# Access Compliance Report

## Public Rights-of-Way

Intersection ID: 12877	Main Street: E_5TH_ST	Cross Street: N_MYERS_ST	Location: S
ADA ID: 8B00F1B5AFA8	Ramp Type: PerpDiag	Initial Pass/Fail: Fail	Overall Compliance: No
		Severity Score: 25

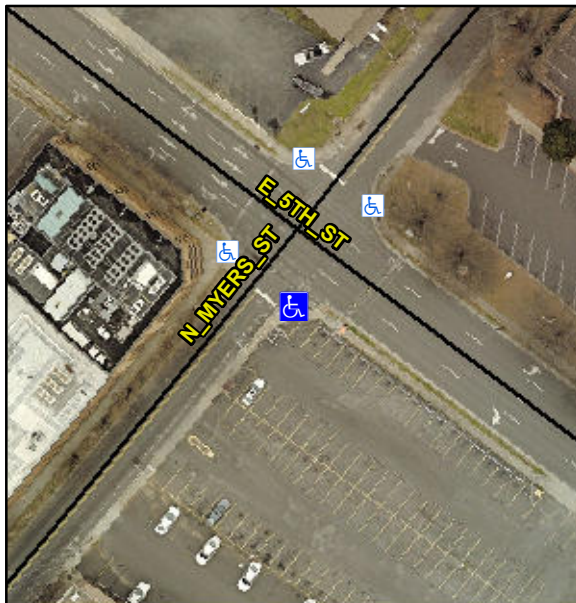
Compliance	Description	Data	Compliance	Description	Data
N/A	Ramp Length (in)	75.0	Yes	Ramp Slope (%)	6.7
Yes	Ramp Width (in)	49.0	No	Ramp XSlope (%)	8.4
N/A	Flare Type LT	N/A	N/A	Flare Type RT	N/A
N/A	Flare Slope LT (%)	N/A	N/A	Flare Slope RT (%)	N/A
N/A	Flare Traversable LT?	N/A	N/A	Flare Traversable RT?	N/A
N/A	Landing Length (in)	N/A	N/A	DWS Provided?	N/A
N/A	Landing Width (in)	N/A	N/A	DWS Contrast?	N/A
N/A	Landing Slope (%)	N/A	N/A	DWS Length (in)	N/A
N/A	Landing X Slope (%)	N/A	N/A	DWS Full Width?	N/A
N/A	Landing Curb? (Y/N)	N/A	N/A	DWS Offset (in)	N/A
N/A	Shared Landing?	N/A			
N/A	Gutter Ponding?	N/A	N/A	Gutter Slope (%)	N/A
N/A	Gutter Lip Ht (in)	N/A	N/A	Gutter X Slope (%)	N/A
N/A	Painted X Walk1?	No	N/A	Painted X Walk2?	No
	X Walk 1 Direction	To NE		X Walk 2 Direction	To NW
N/A	X Walk 1 Width (in)	N/A	N/A	X Walk 2 Width (in)	N/A
	X Walk 1 Slope (%)	5.9		X Walk 2 Slope (%)	8.8
	X Walk 1 X Slope (%)	10.0		X Walk 2 X Slope (%)	0.0

**Remove & Replace Curb Ramp With Two New Directional Ramps or Equivalent.**

**R304.5.3**
